Service Bulletin

Category B	Applicable Model/s 1988-90 626/MX-6 ATX	Subject IDLE VIBRATION IN "D" RANGE	Bulletin No. 001/90 Issued 4/20/90 Revised
---------------	---	--	--

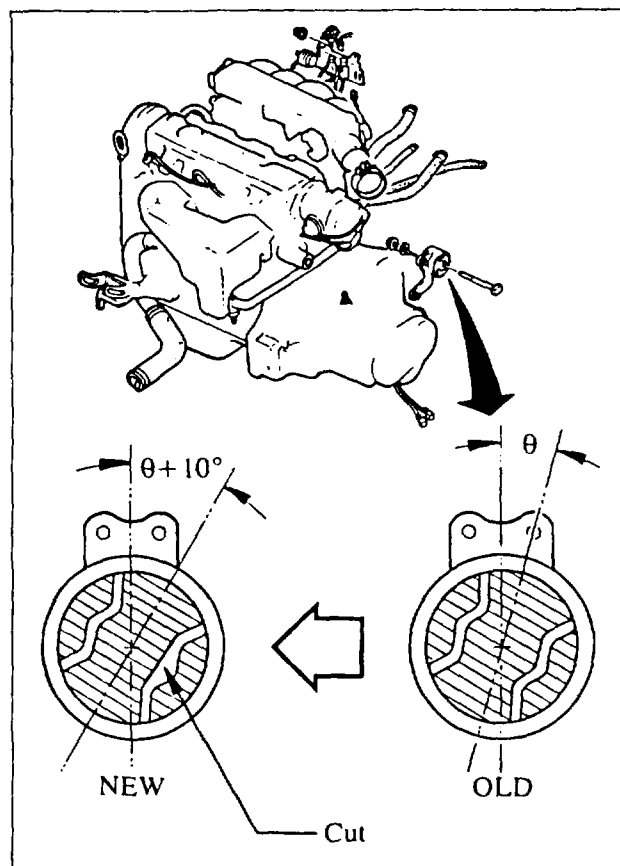
No. 1 engine mount and radiator lower mount rubbers have been changed as follows:

• No. 1 Engine Mount

- The diameter of the rubber has been increased from 3.15 in. to 3.54 in. since the November, 1988 production.
- The rubber has been turned 10° toward the engine side since the November, 1988 production.

• Radiator Lower Mount

- Changed since June, 1989 production.

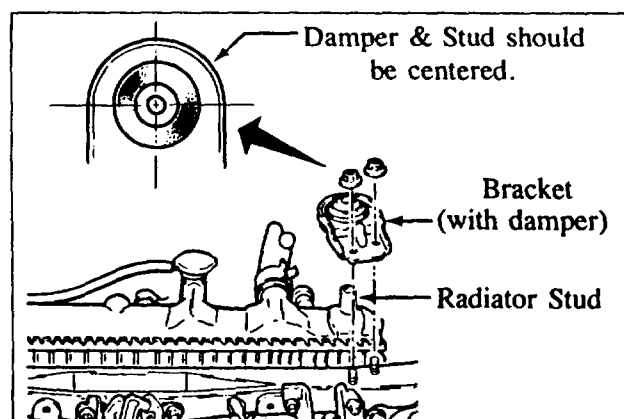
1. Check that the idle speed is within the specification.

Idle Speed: 750 ± 25 RPM (in P range)

If the idle speed is not within the specification, adjust it to 750 RPM with test connector grounded.

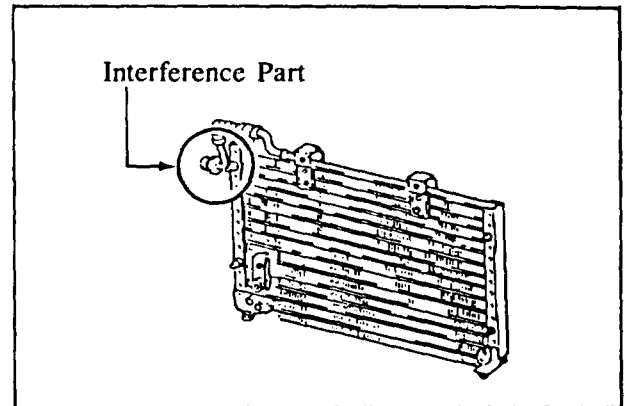
3. Check that the radiator is centered in the radiator upper brackets so that it can move more effectively as a dynamic damper. If not, adjust the radiator or the brackets as follows:

- Adjust the position of the upper brackets.
- Adjust the position of the radiator upper hose so the radiator is not pushed or pulled out of position.

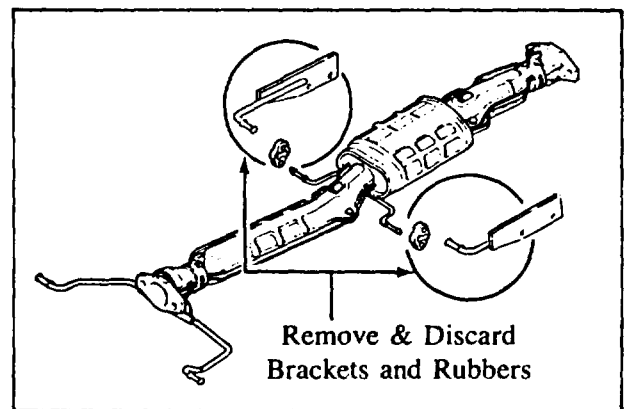
4. Check if the A/C pipe (from compressor to condenser) is not interfering with the radiator. If necessary, reposition the A/C pipe to make enough clearance between the A/C pipe and the radiator.
